Design Compliance Report

REF Submission Design Review

Dalmeny Public School Upgrade

| Report Number & Revision: | MSA2623_BCA_DAL_3.0 |

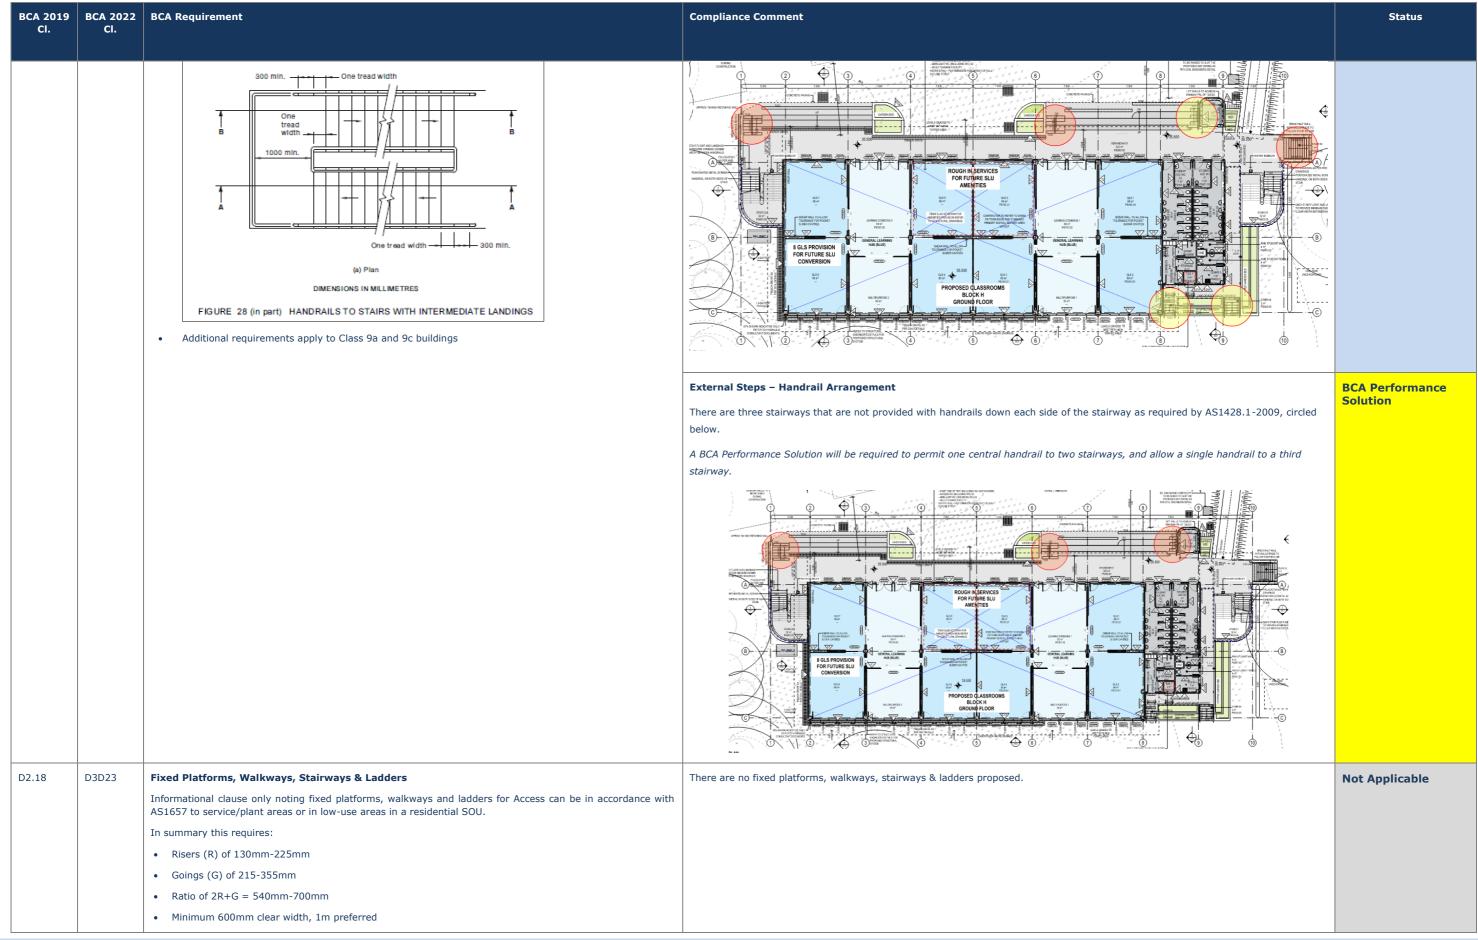
| BCA 2019 Cl. | BCA 2022 Cl. | BCA Requirement | Compliance Comment | Status |
|---------------------------|-----------------|---|---|----------------------------|
| D2.17 | D3D22 | Handrails A handrail is required to at least one side of every stairway or ramp (and to both sides where the stair has a width of 2m or more) Handrails must be at a height of not less than 865mm above the stair nosing line (additional handrail at 665-750mm to be provided in primary schools) The handrail must be continuous between stair flight landings and have no obstructions that will tend to break a hand-hold (except for newel posts, ball type sanctions or the like). Handrails required to assist people with disabilities must comply with BCA D3.3. In a required exit, the handrail must comply with Clause 12 of AS1428.1. This typically requires the handrail to have a continuous height to the stair nosing line & around landings, and also incorporate extensions/terminations at the top and bottom as per AS1428.1. | The stairway handrails marked in orange circles below are considered compliant. Detailed plans of all other stair handrails (yellow circles) to be provided for review to confirm compliance, including 300mm handrail extensions to all stairs. | Further Detail Required |

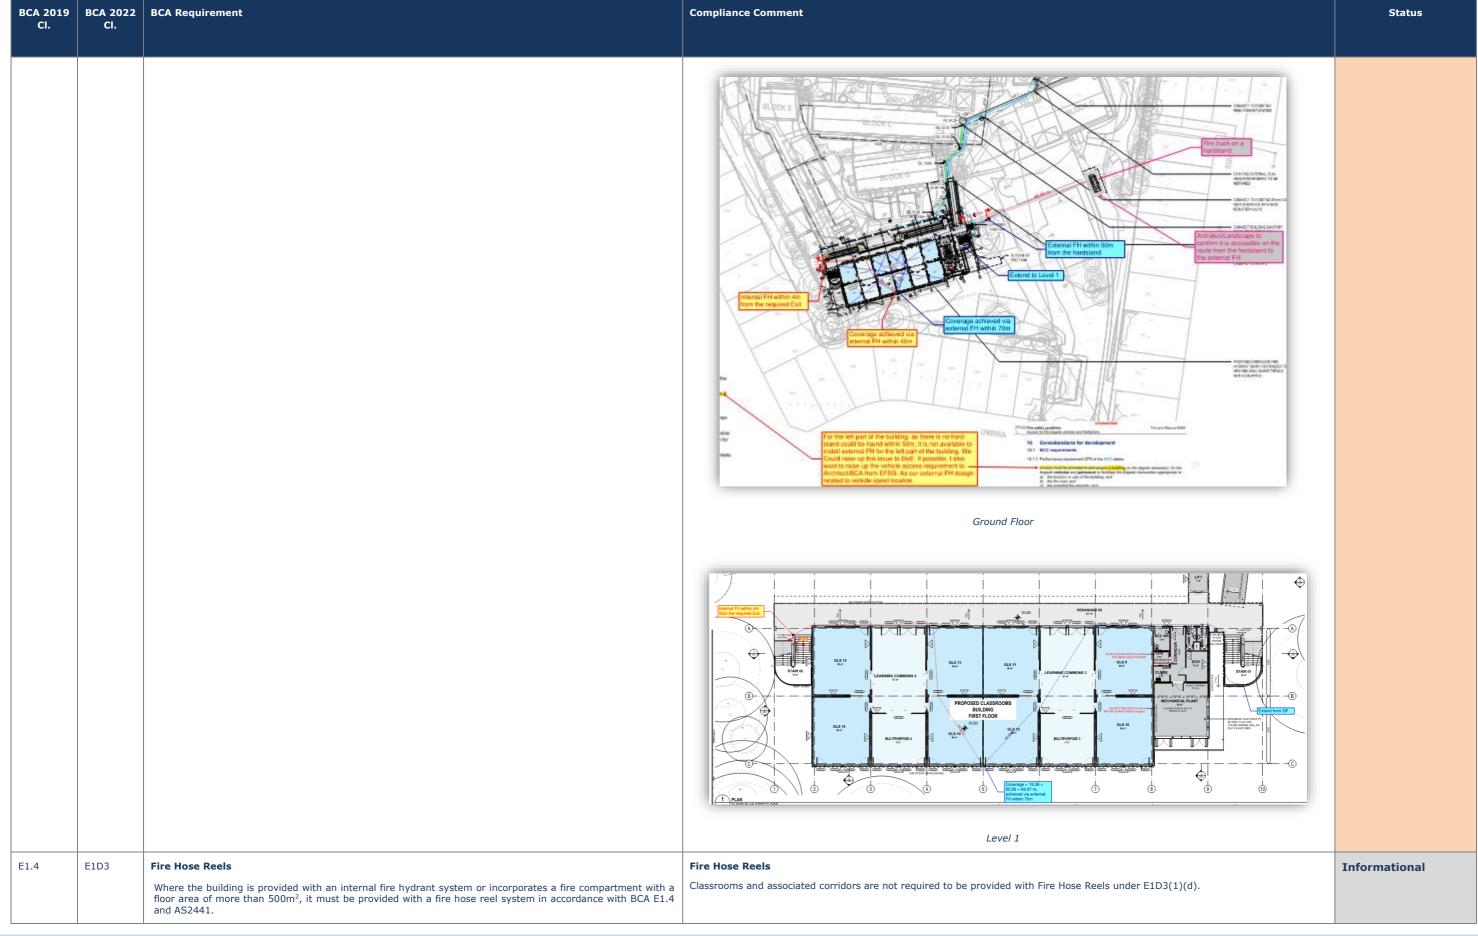
| BCA 2019 Cl. | BCA 2022 Cl. | BCA Requirement | Compliance Comment | | | Status |
|-----------------|---|--|--|-------------------|---|--|
| 3 | Fire Hydrants Fire hydrant coverage meeting AS2419.1 must be confirmed / provided: to new buildings or new parts that are over 500m² in total floor area to any additional floor area in an existing building that is already provided with hydrant coverage Hydrant Boosters & Hydrants (where required) must be 10m from the building or adequately protected from fire | | considered occupiable outdoor areas Details and design certification mus Fire Hydrant Coverage | t be provided by | the hydraulic/fire services engineer. to all areas on Block H as per the diagrams below. | Certification by Designer or Specialist Certification by Designer or Specialist |
| | Hydrant Pumprooms (where required) must be accessible from open space or via fire isolated passage Coverage and pressure & flows must meet AS2419.1-2005 | | | | Specialist | |
